Administrative Review

Date: March 10, 2023

Subject: **Case #2023-01 689 North Main Street, LLC and Salt Creek Properties, LLC. for the property located at Tax Map 43, Lot 20-2. Special Exception Application**

ZBA EXHIBIT IMPACT PLAN SET

WETLAND IMPACT PLAN
MILFORD RASHID GAS STATION

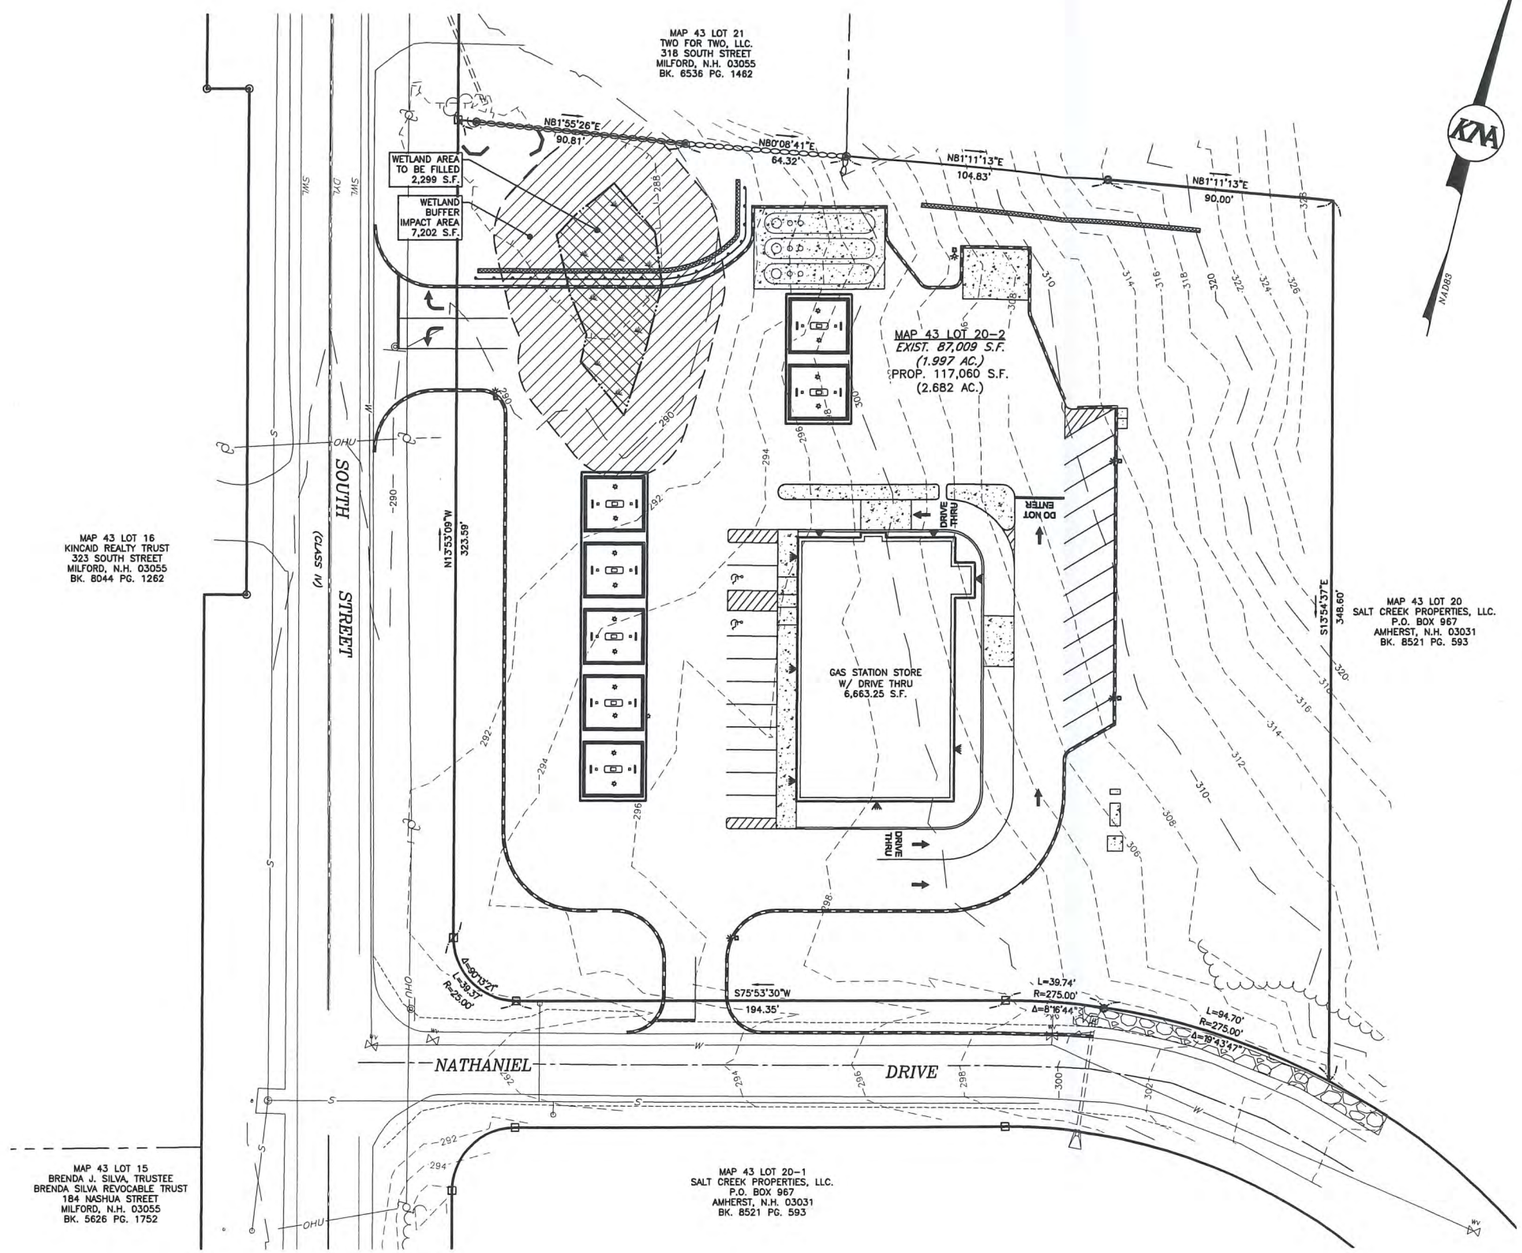
a. The applicant should explain what alternatives designs and or layouts of the proposed driveways and site were considered to minimize the overall impact to both the delineated wetland resource area and buffer.

b. The applicant should explain what stormwater management design alternatives were considered to (1) minimize the overall impact to both the delineated wetland resource area and buffer and (2) manage the existing stormwater volume and flow from the abutting parcels.
